Re: Final Plat S/D 87-9 - HILLSIDE GARDENS 2ND ADDITION

At the regular meeting of the Subdivision Committee of the Metropolitan Area Planning Commission on Thursday, February 12, 1987, the above-captioned plat was considered. The action of the Committee was to recommend that this plat be approved subject to:

Final Plat
SUBDIVISION REPORT

Name: HILLSIDE GARDENS 2ND ADDITION

OFFICE COPY
DO NOT REMOVE
FINAL PLAT

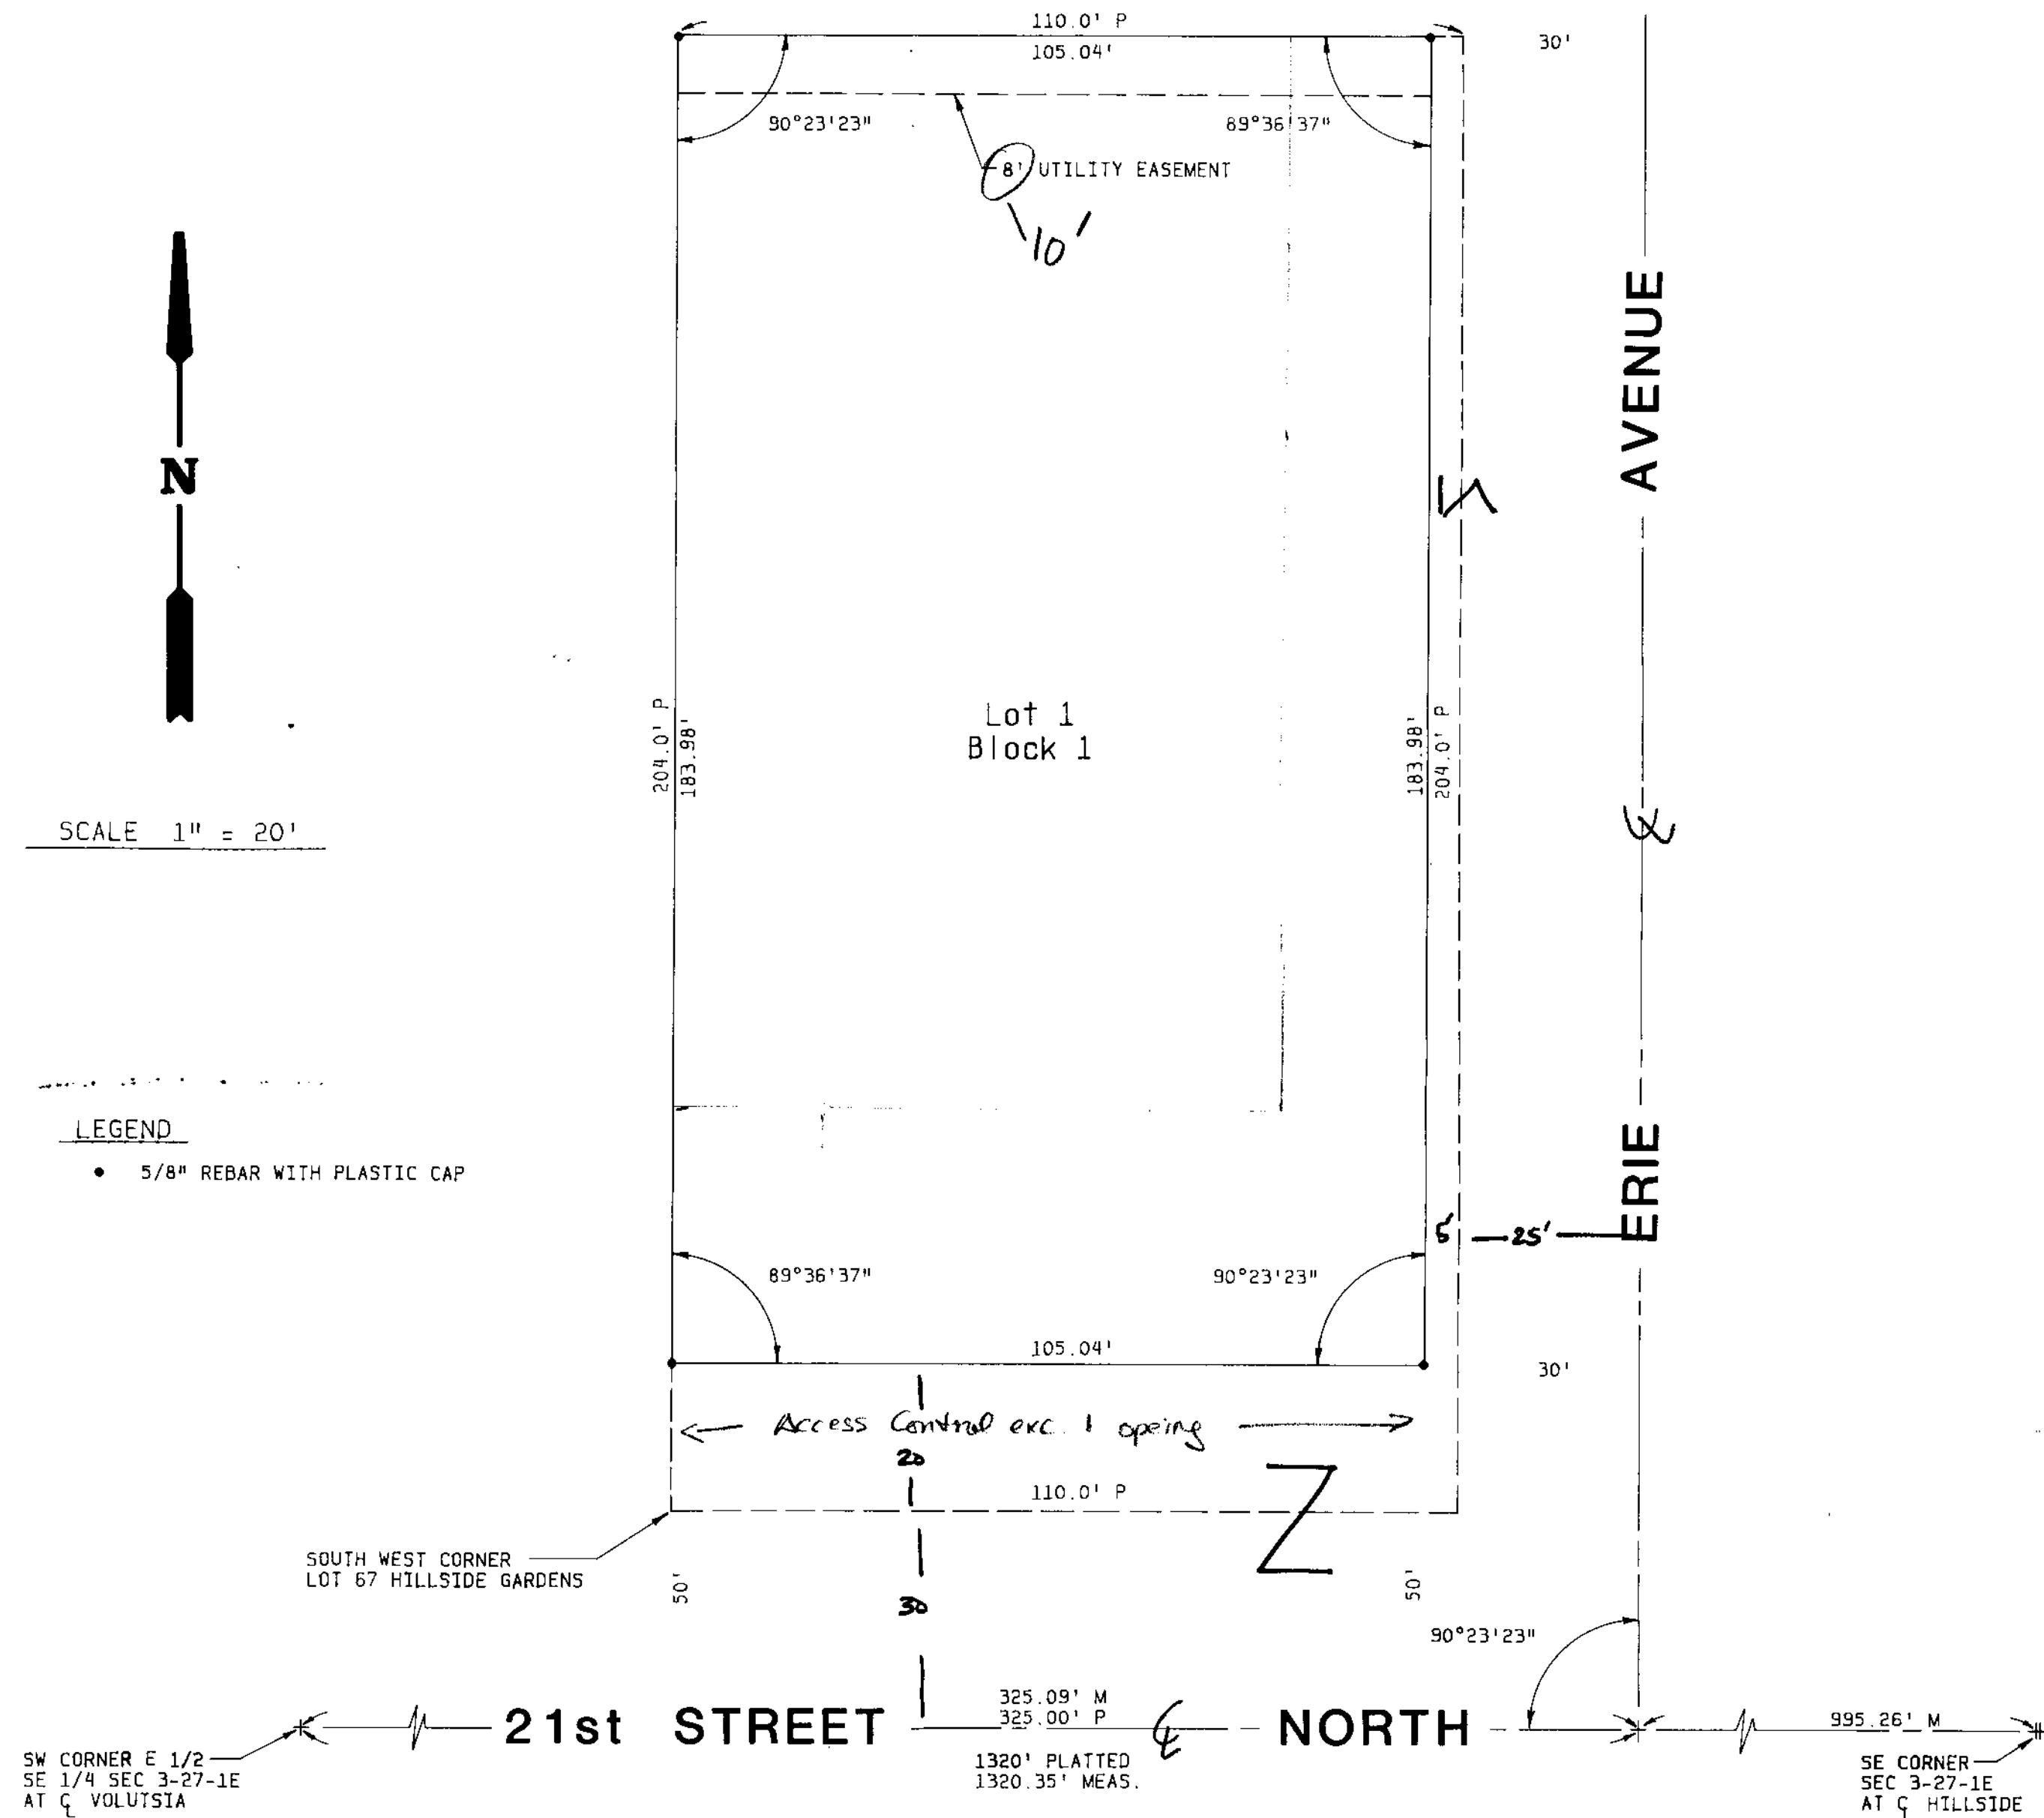
- Needs*
- A. The final plat tracing shall indicate the platting of "access control except for one opening" to 21st Street North across the south line of this lot. The platting of this access control shall be referenced in the platlor's text. *Need to add phrase about permit to be determined by the City Engineer.*

- ~~B.~~ The final plat shall indicate the amounts of half-street rights-of-way adjacent to the plat as well as the amount of additional rights-of-way being dedicated by this plat.

- ~~C.~~ The final plat tracing shall label the centerlines of the adjacent perimeter streets.
 - ~~D.~~ The final plat shall indicate a 10-foot utility easement adjacent to the north line of Lot 1, Block 1.

- ~~E.~~ Since an existing sidewalk system does not exist to the north, it is recommended that the sidewalk required on Erie, by this lot's commercial zoning, be waived.

- ~~F.~~ The final plat tracing shall indicate a 35-foot building setback from 21st Street North and a 20-foot wide building setback from Erie Avenue. Section 28.04.188.8 of the City's Zoning Ordinance provides for the construction of detached canopies within building setbacks.

THIS PLAT APPROVED BY THE SUBDIVISION
COMMITTEE ON 2/12/87 SUBJECT
TO THE CONDITIONS OUTLIN-
ED IN OUR LETTER DATED 2/12/87
